Final report - Review of built infrastructures

Khammouane Province - Laos 2017

Title:	Construction review in Laos - Final report
---------------	--

Date and place:	Luxembourg – 2017.02.10
Project name & code	Laos constructions review – 24LA00
Service client	AI Croix-Rouge luxembourgeoise – Beatrice Winandy

Perimeter wall in 2 layers

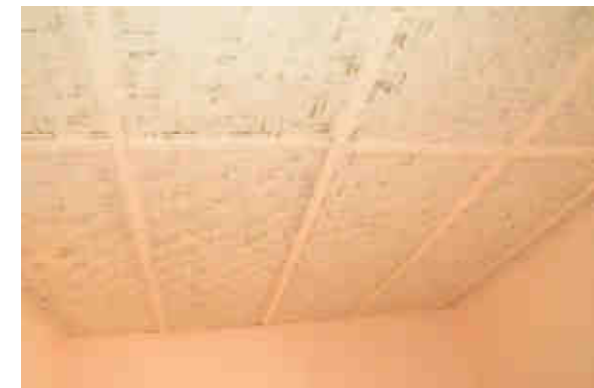
the sand by itself.	
Stairs to access.	03.08.2017	Interview + picture + measure	L=4m; stair in brick changed only one stair built	The stair in the rear side of the building have to be done
Stairs to access.	03.08.2017	Interview + picture + measure	L=9.35m; stair on brick over slab	General aspect is good but the dimensions in the steps are different
Ramp to access.	03.08.2017	Interview + picture + measure	3x2.5; stair on brick over concrete slab	High pendent on the ramp

Junction with metallic plate and bolt

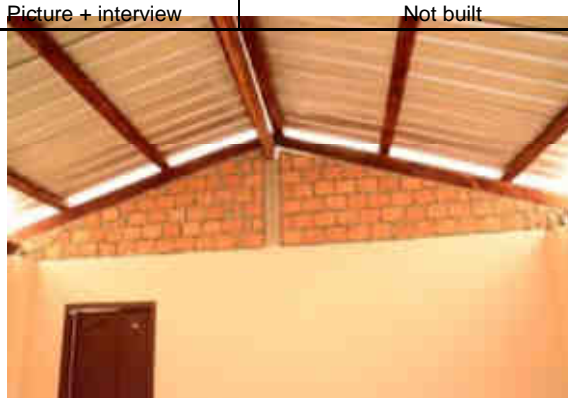
Enclosure of the interior spaces	2017.03.09	Picture + interview	The plaster is NOT finished +painted Lintel beam 10x15 +2/D=10 Wall H=2.50	General aspect is good but the interior plastering is not finished. The company added the beams, the technical follow-up from the district approved but did not inform
Wood door. Type D1	2017.03.09	Picture	Green wood, no full insect protection	The changes where suggested by district, construction company accepted and LRC delegate informed HQ. In general the quality of the doors is poor. The wood needs to be dry and protected against insects
Int/Ext painting	2017.03.09	Picture	Painted outside / not finished inside	N/C
ROOF COVERING	Date of visit	Measure of verification	Collected data	Comments
Metal sheeting roof over wood substructure	2017.03.09	Pictures + interview	ALUZINC Metallic sheet e=0.47mm Structure: Nailed joint over the walls in the wood beam Wood not fully protected beam on the bridge with bolt and metallic plate	The construction company changed or built the roof structure differently. The technical control/follow-up didn't inform about changes, missing pieces or irregularities.

General view including bamboo wall

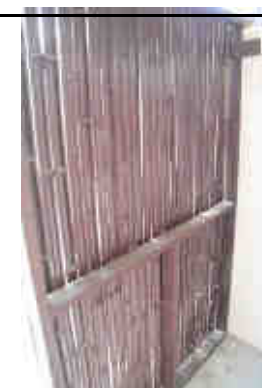
Door. Type "toilet"	2017.03.10	Picture+measure	Green wood, no full insect protection W+=0,805 h=2,05	
Int/Ext painting	2017.03.10	Picture	Painted	N/C
Wood + bamboo toilet wall	2017.03.10	picture +interview+	Framework painted and nailed No bracing Metallic L piece + screw for junction with ground	The general exterior aspect is friendly and good finishing. The bamboo solution on the walls allow ventilation
